Comments on Covariance Data of JENDL-4.0 and ENDF/B-VII.1

April 22, 2014

M. Ishikawa, JAEA

Fe-56 Mu-bar (1/3)

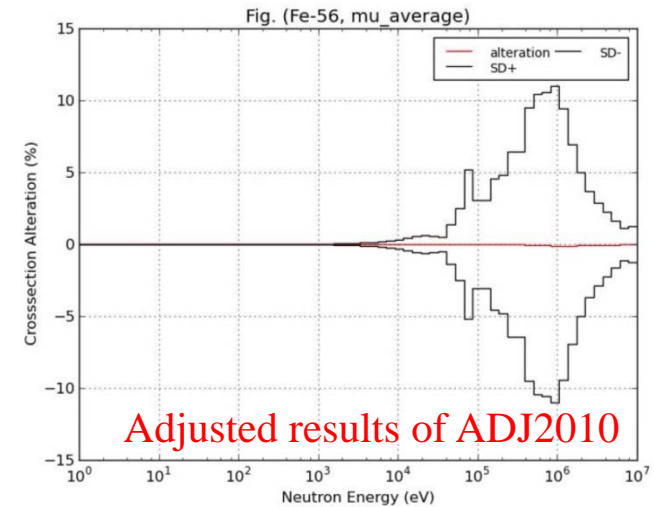
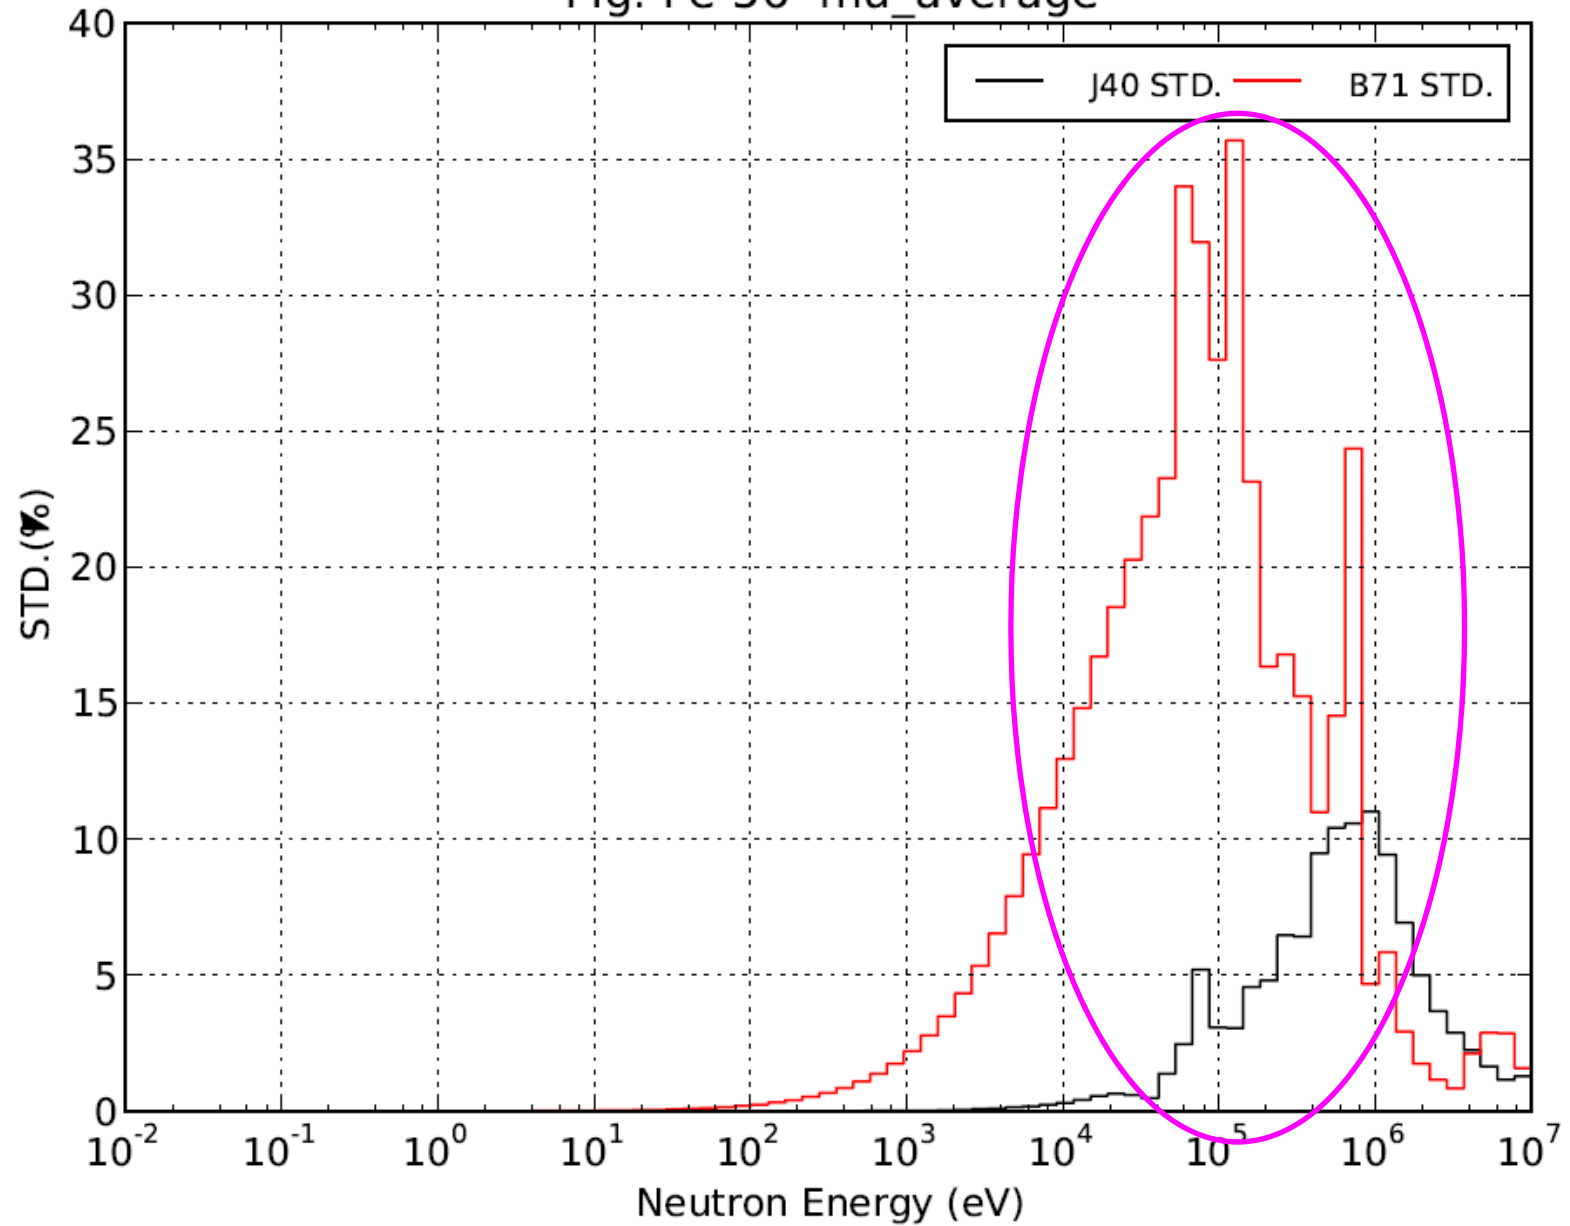
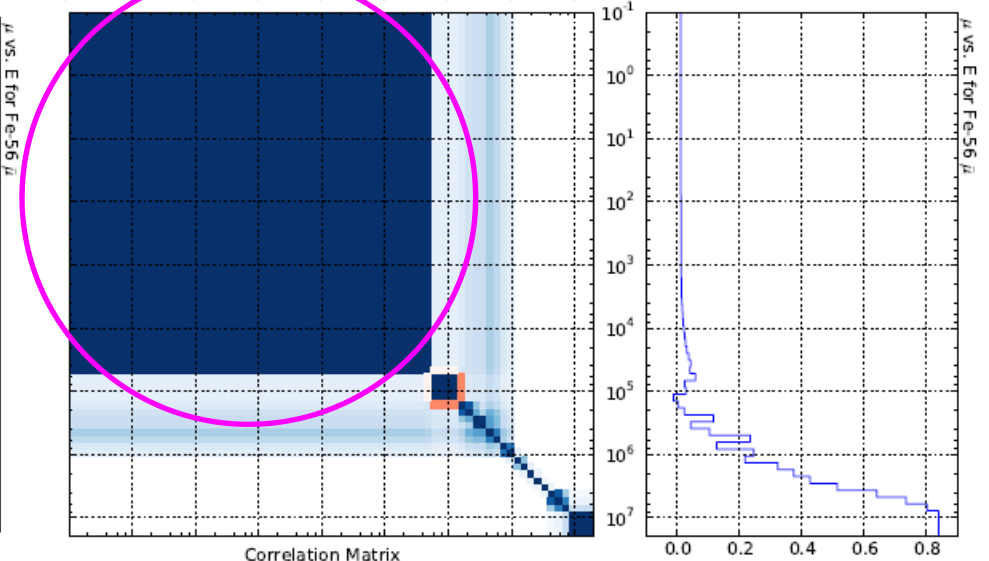
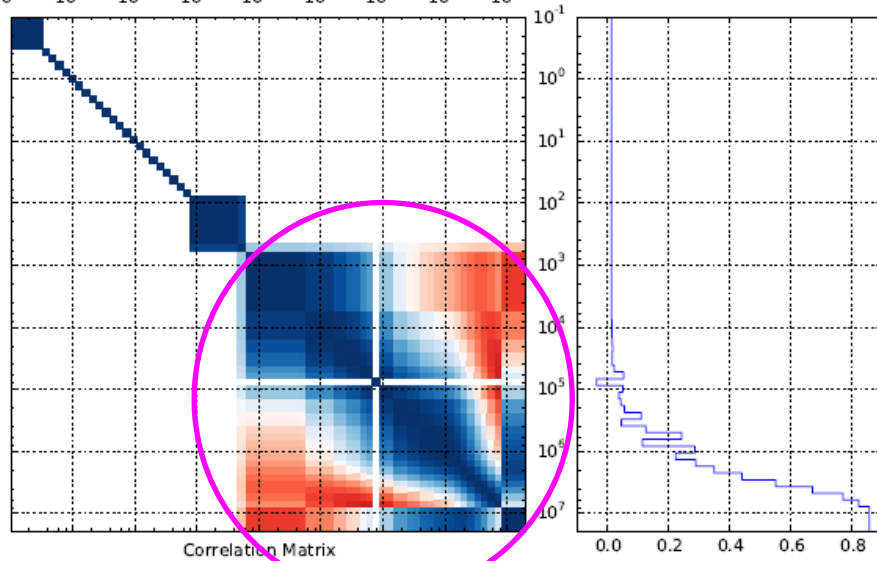
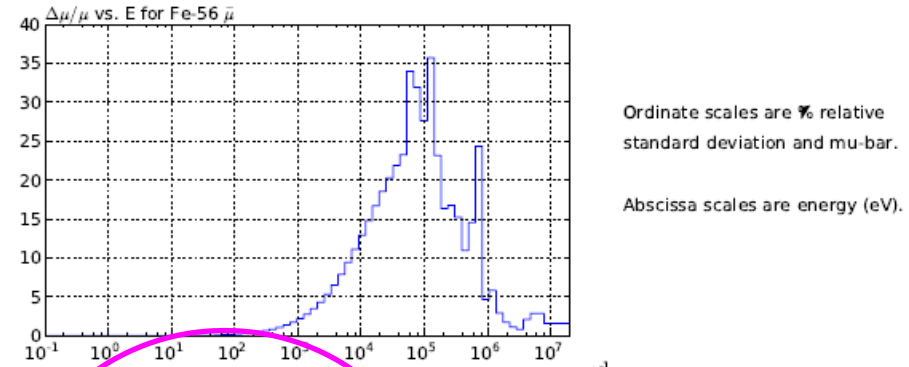
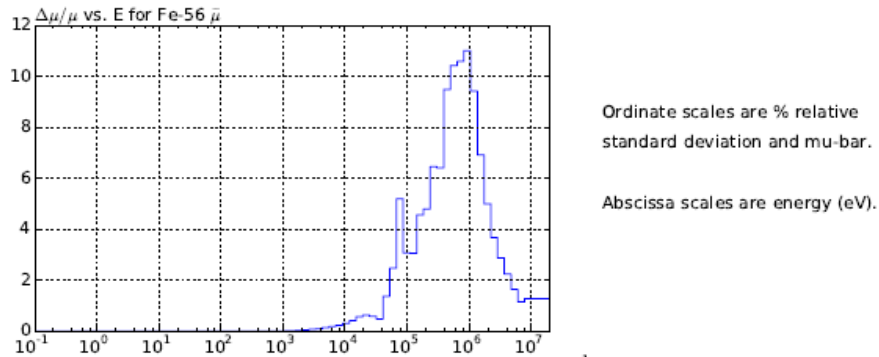
In **JENDL-4.0**, the maximum value of **STD** is **10%**, on the other hand, **30%** in **ENDF-7.1**. The **negative correlation** appears in **JENDL-4.0**, **NOT** in **ENDF-7.1**. Further, The correlation factors are **1.0** below **50keV** in **ENDF-7.1**.

The covariance of **JENDL-4.0** was evaluated with **ELIESE3-KALMAN** in 1997^(J-4, p.8). That of **ENDF-7.1** may be Kernel approximation as well as that of the elastic cross-section^(E-2, p.15). The reason of large differences are unknown.

SG39 should **ask the reason** of the large differences to both **JENDL-4.0** and **ENDF-7.1** **evaluators**. Besides, **ENDF-7.1** has only the mu-bar covariance for **Na-23**, **Fe-56** and minor actinides, but that of **other isotopes such as U-238** is also **necessary** for the reactor application.

Na-23 Capture (1/3)

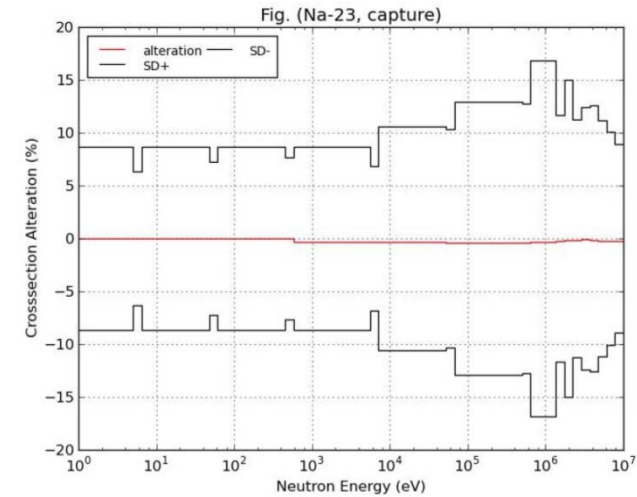
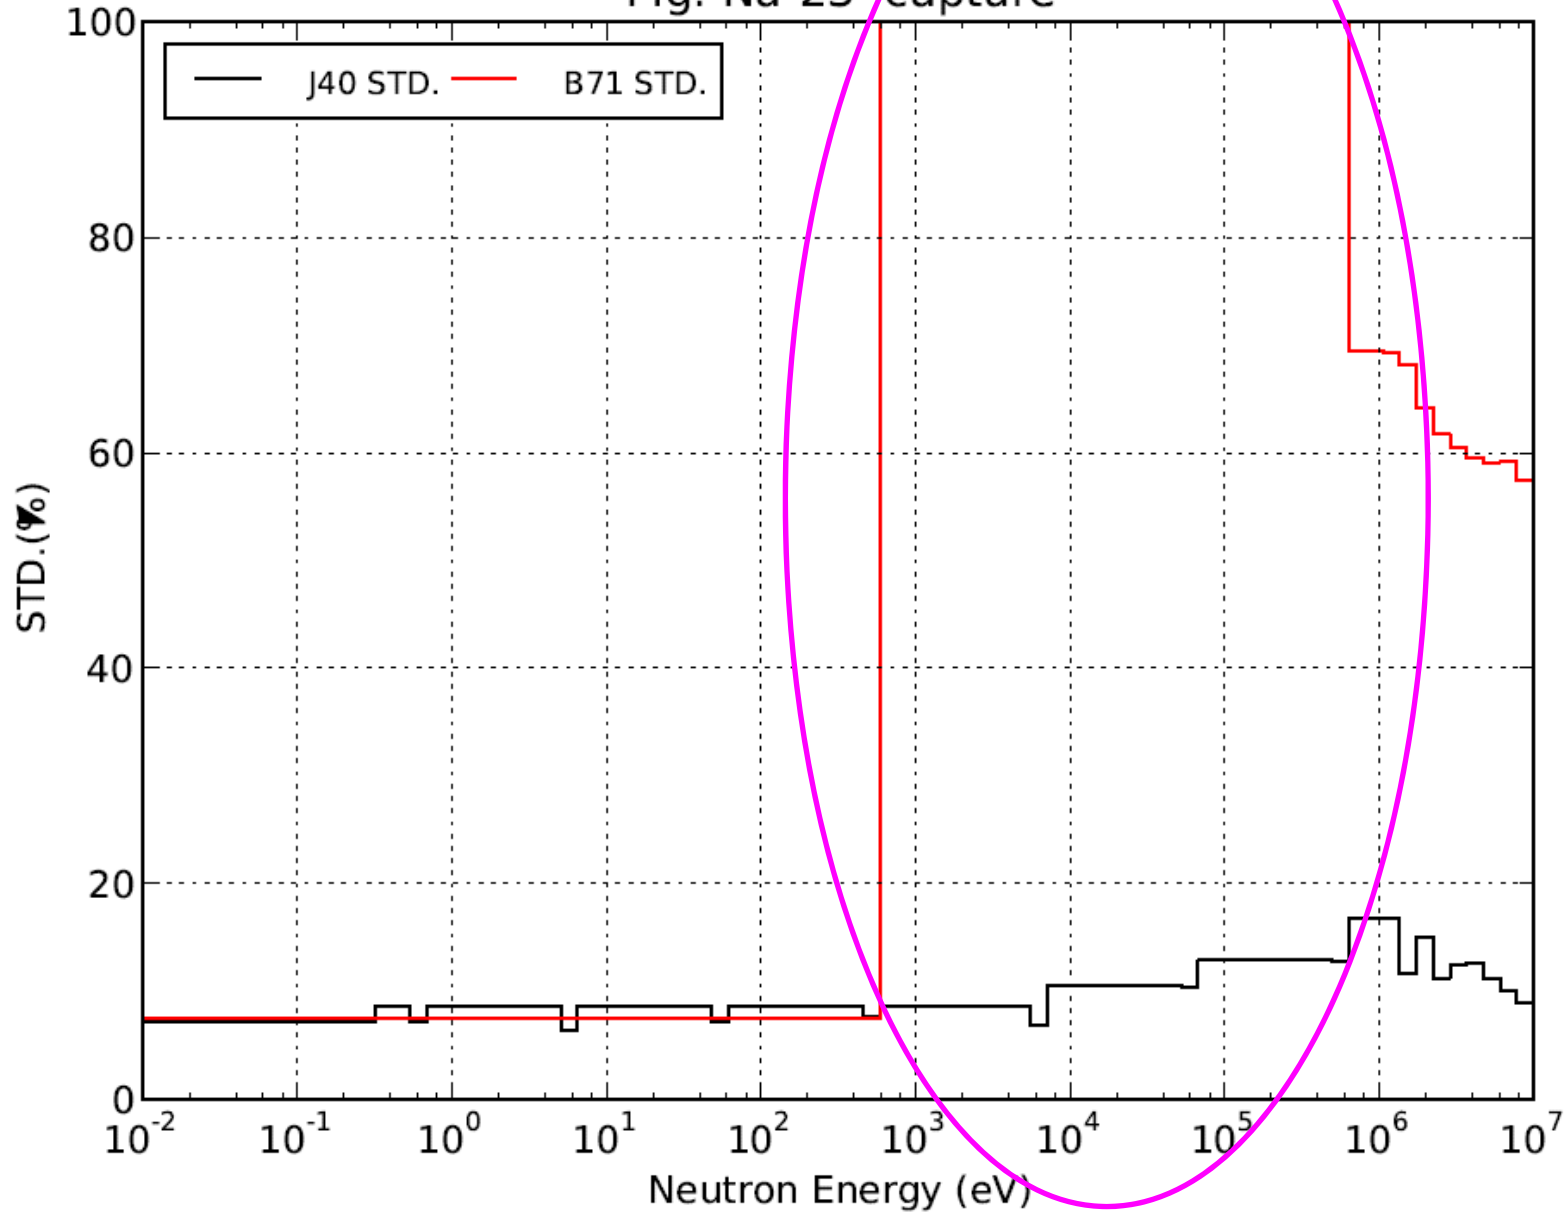
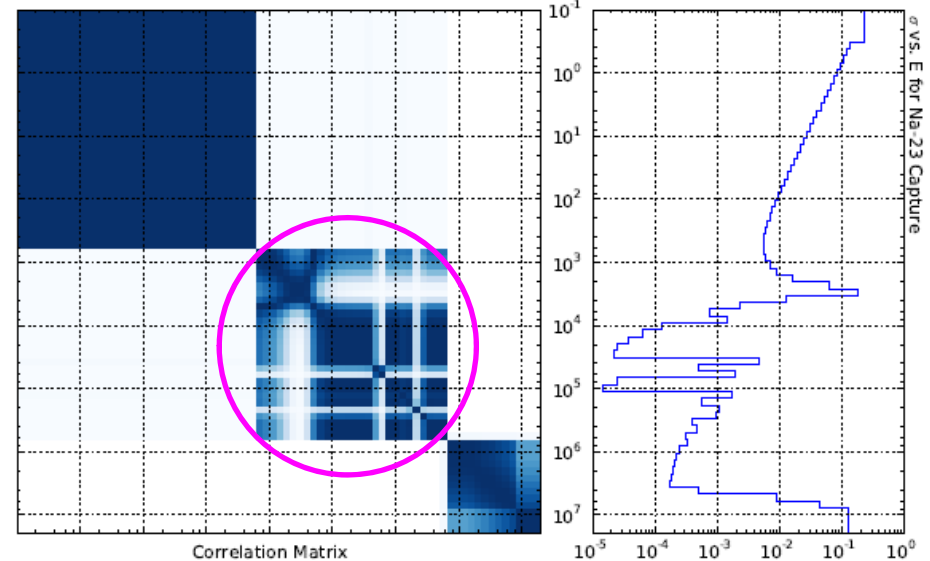
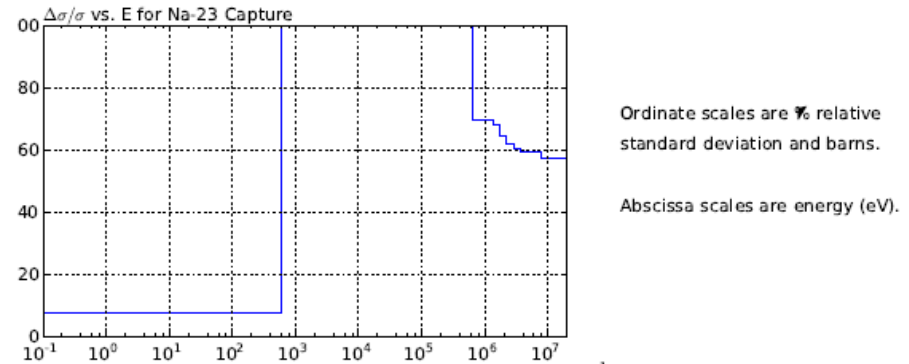
In **JENDL-4.0**, the **STD** value is approximately **10%**, on the other hand, **100% in ENDF-7.1**, although the cross-section values are very small, the order of **milli-barn**.

The covariance of JENDL-4.0 was evaluated from the experimental values with the least-square fitting^(J-3). ENDF-7.1 adopted the results of EMPIRE-KALMAN^(E-2, p.14). The 100% STD of ENDF-7.1 might be the a priori guess which was not changed due to the large experimental uncertainty.

Though this reaction is not important for the reactor application, there would be some concerns from sodium activation viewpoint. It is **better to ask the reason of the STD differences between 10% and 100%** to both **JENDL-4.0** and **ENDF-7.1** evaluators.
